**Addendum No. 3
To the Plans, Specifications, Proposal and Contract**

**City of Kirkland
Fire Station 24
9824 NE 132nd ST, Kirkland WA 98034
CIP # PSC 3002 200
JOB # 32-20-PW**

ISSUED THIS DATE: August 13, 2020

REVISED 101 LOBBY INTERIOR ELEVATIONS		REFERENCE NUMBER: AD3 ASK1
	SCALE: 1/4" = 1'-0"	DATE: 08/13/20	PROJECT NO: 16-46
6211 ROOSEVELT WAY NE SEATTLE, WA 98115 tel: (206) 522-3830

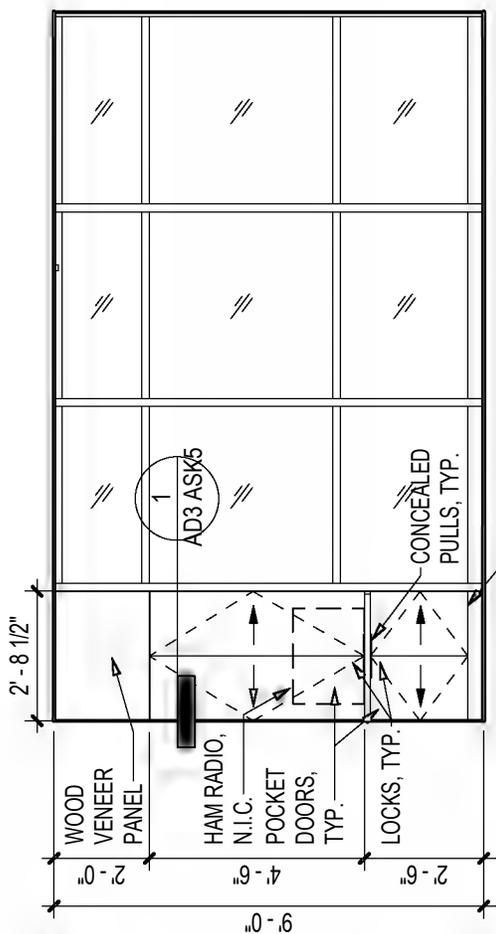
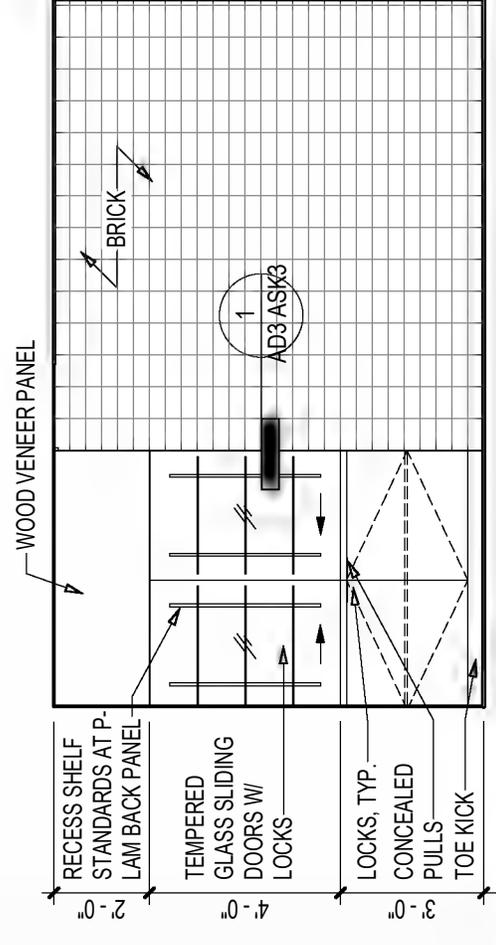
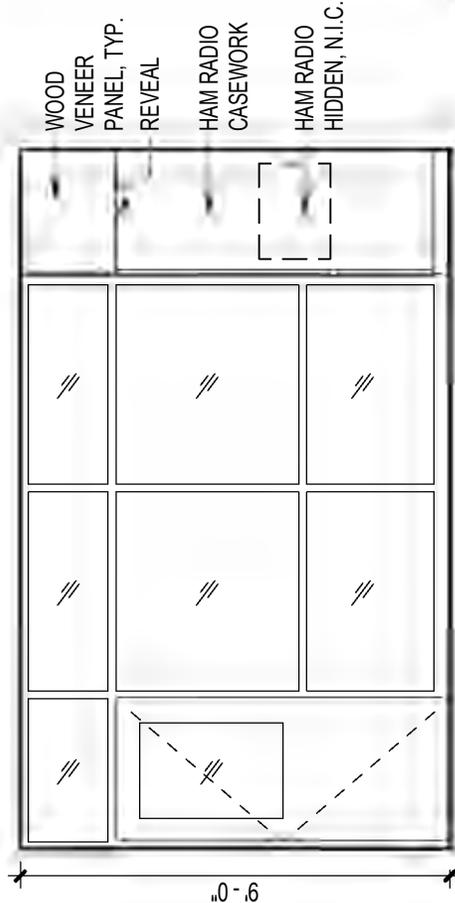
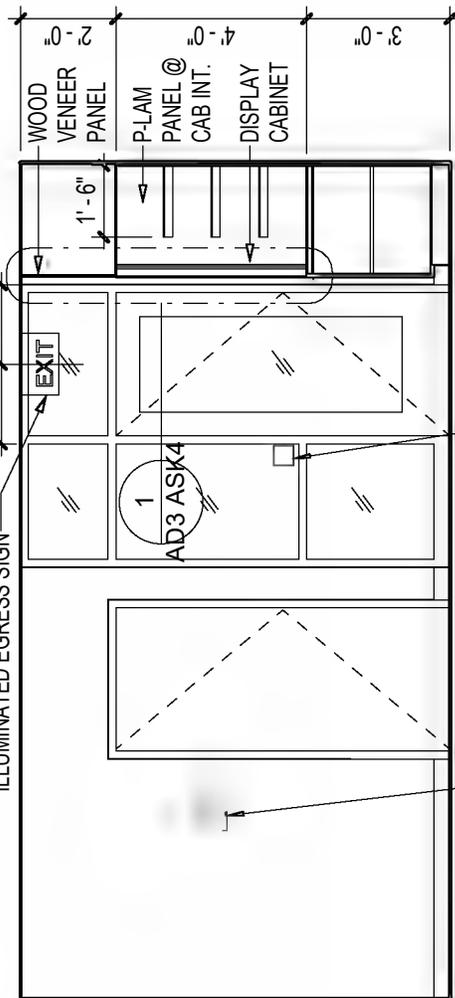
- a. Interior Elevations 2 and 2b: Replace elevations with attached AD3 ASK1 - REVISED 101 LOBBY INTERIOR ELEVATIONS.

REVISED INT. CORNER @ INT. BRICK VENEER

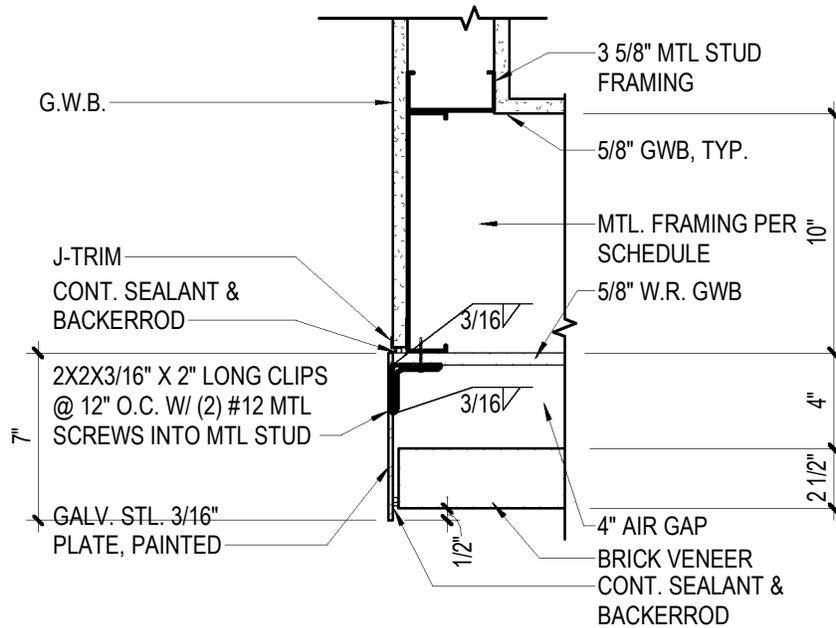
- a. Detail 10: Replace with attached AD3 ASK2 - REVISED INT. CORNER @ INT. BRICK VENEER.

DISPLAY CASE CABINET SECTION

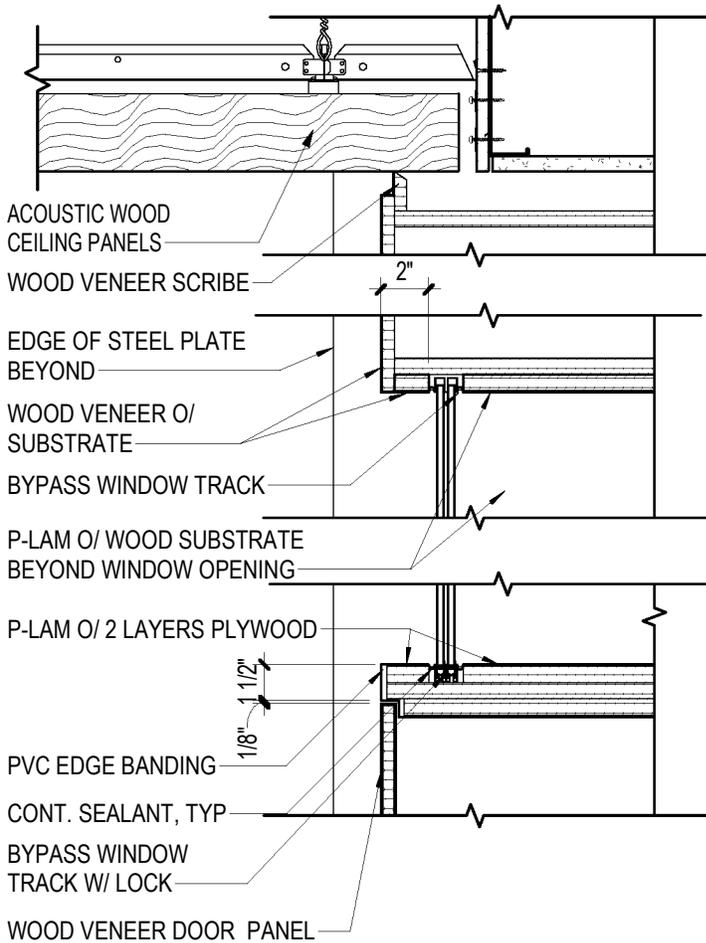
- a. Detail 11: Replace with attached AD3 ASK3 - DISPLAY CASE CABINET PLAN.
- b. Detail 12: Add attached AD3 ASK4 - DISPLAY CASE CABINET SECTION.
- c. Detail 13: Add attached AD3 ASK5 - RADIO CABINET PLAN.
- d. Delete Detail 10.

REVISED FOLDING DOOR THRESHOLD

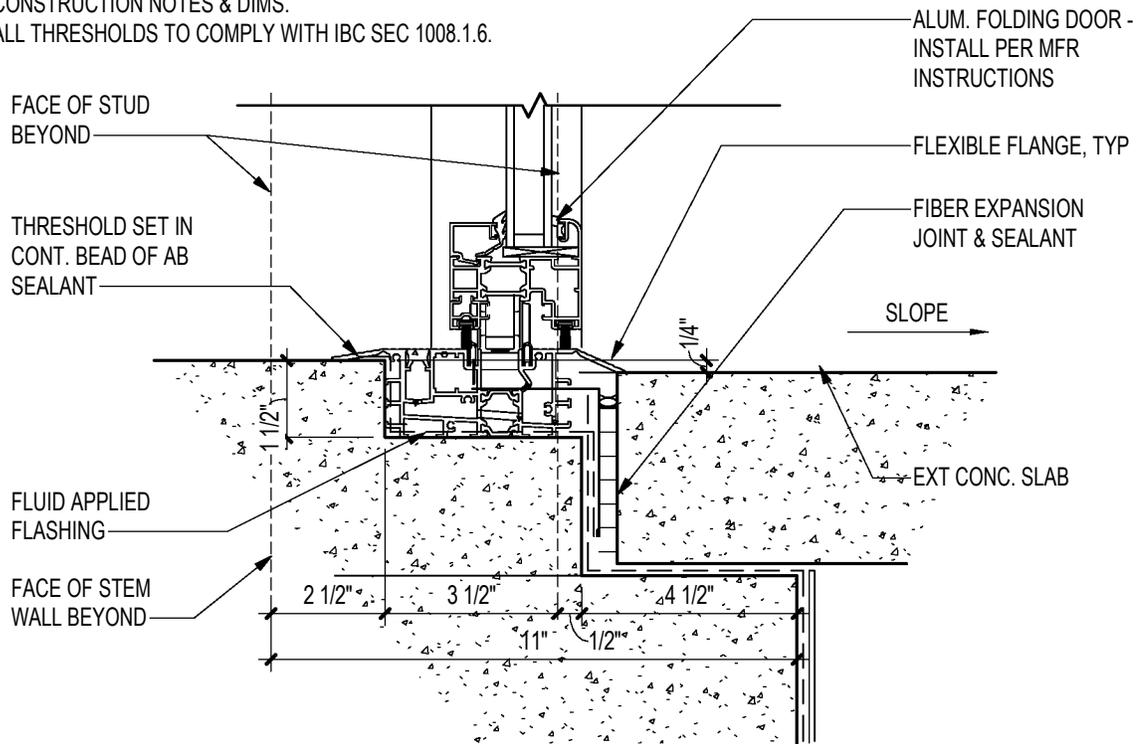
- a. Replace Detail 19 with REVISED FOLDING DOOR THRESHOLD per AD3 ASK7 -attached.

REFERENCE NUMBER: AD3
 ESK-1
 REFERENCE SHEET:
E1.1

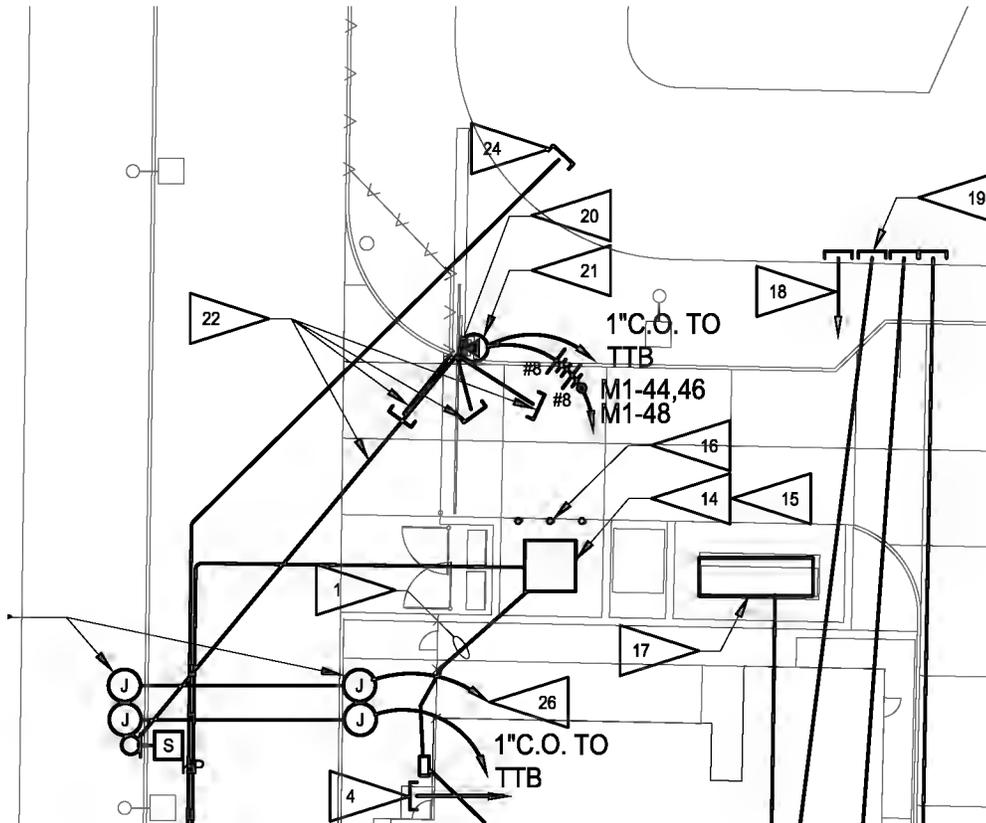
- a. Add 120v/1P circuit at motorized vehicle gate for Click-2-Enter system per attached sketch AD3 ESK-1.
- b. Revise General Note 2 to read:
"Contact Puget Sound Energy Service Representative Ehsan Estiri (Ehsan.Estiri@pse.com) when vault, conduits and service are ready for inspection."

SCALE:	NONE	REFERENCE NUMBER:	AD3 ESK-2
DATE:	08/13/20	REFERENCE SHEET:	E4.1/E4.2
PROJECT NO:	16-46

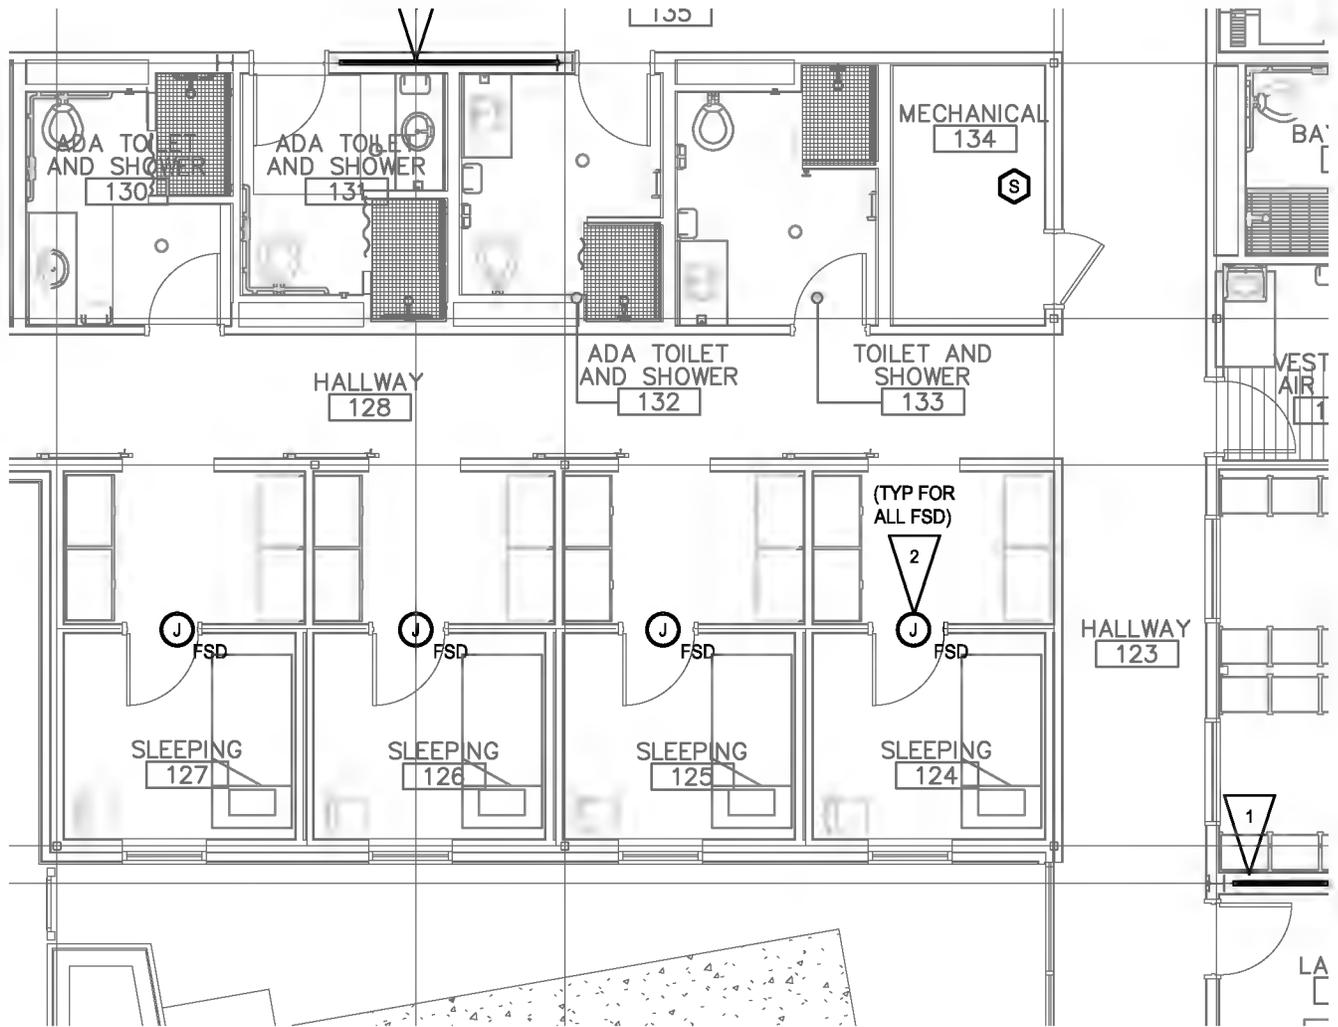
- a. Add General Note 7 per attached sketch AD3 ESK-2.

- a. Add Flag Note 2 per attached sketch AD3 ESK-3.
- b. Add Flag Note 2 to Fire/Smoke Dampers, typical for all Fire/Smoke Dampers per attached sketch AD3 ESK-3.

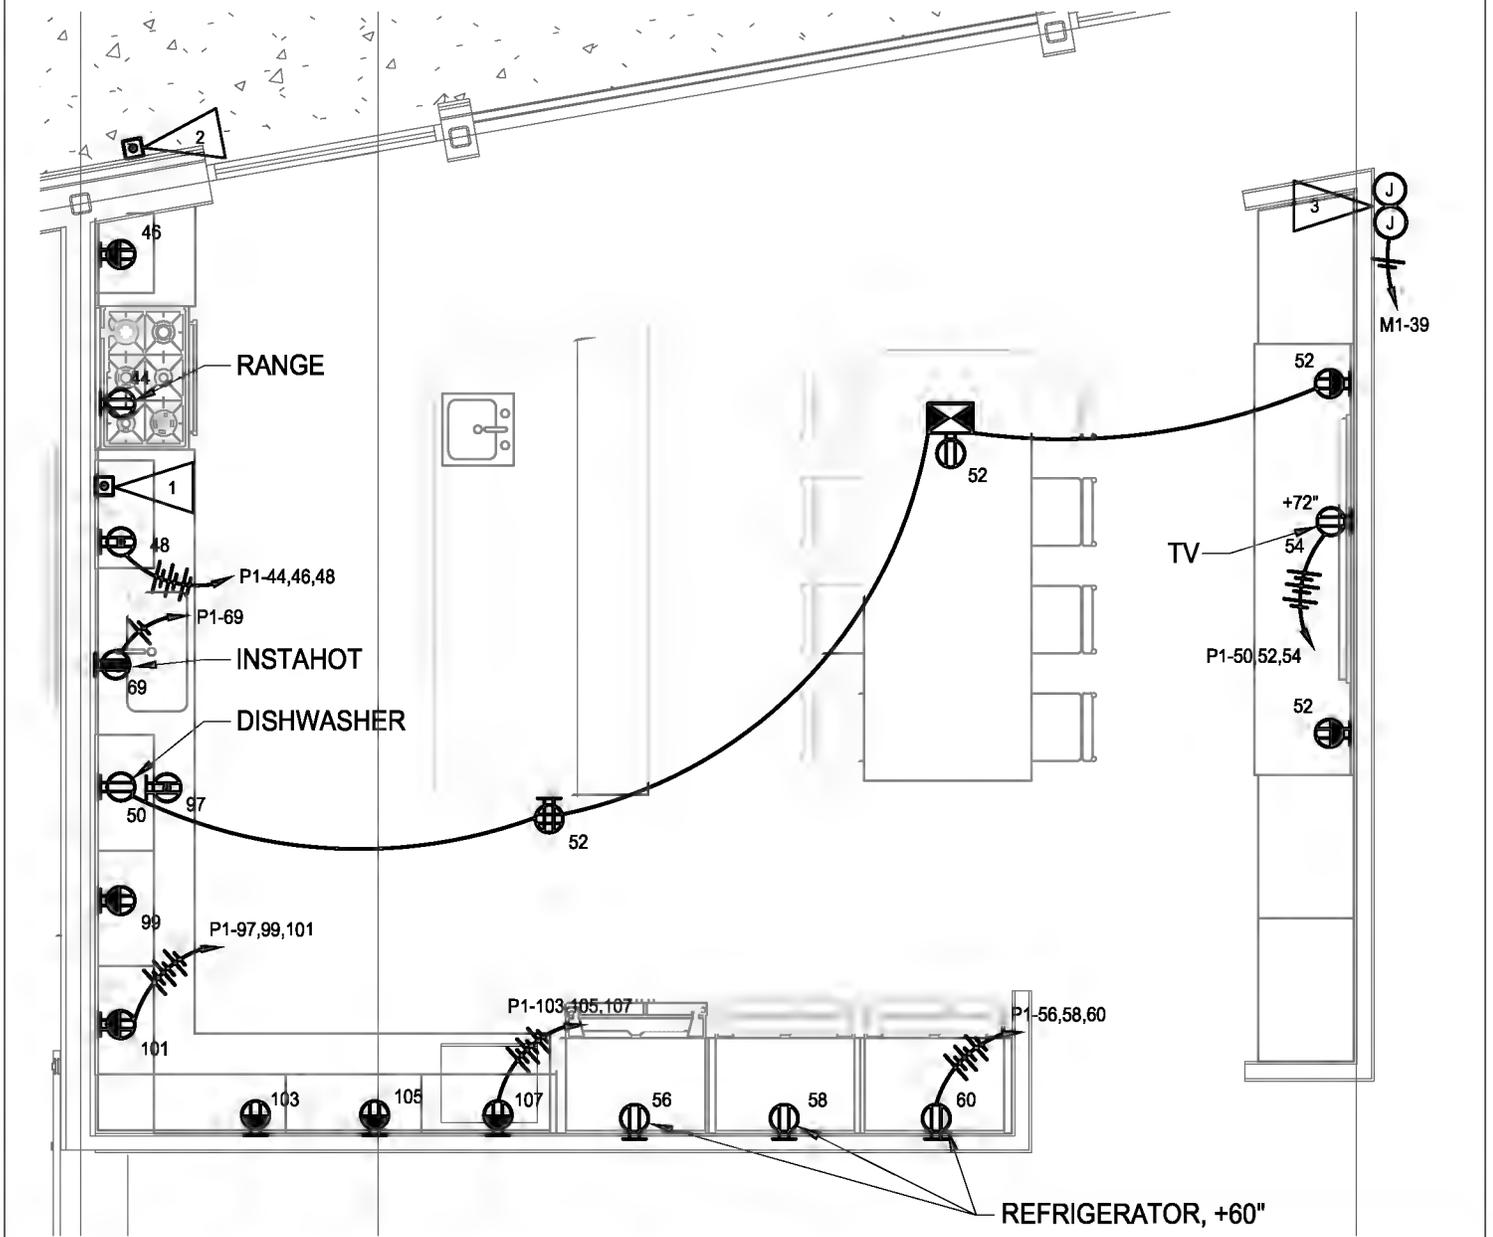
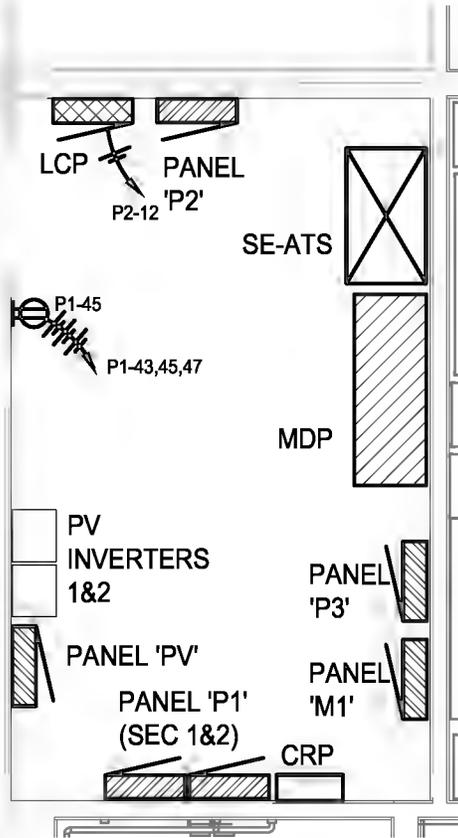
- a. Kitchen Enlarged Plan: Recircuit receptacles above counter per attached sketch AD3 ESK-4.
- b. Kitchen Enlarged Plan: Add gas solenoid reset pushbutton switches per attached sketch AD3 ESK-4.
- c. Kitchen Enlarged Plan: Add power connection for gas solenoid valves per attached sketch AD3 ESK-4.
- d. Kitchen Enlarged Plan: Add Flag Notes 1, 2, and 3 per attached sketch AD3 ESK-4.
- e. Electrical Room Enlarged Plan: Add circuit and homerun at LCP per attached sketch AD3 ESK-5.
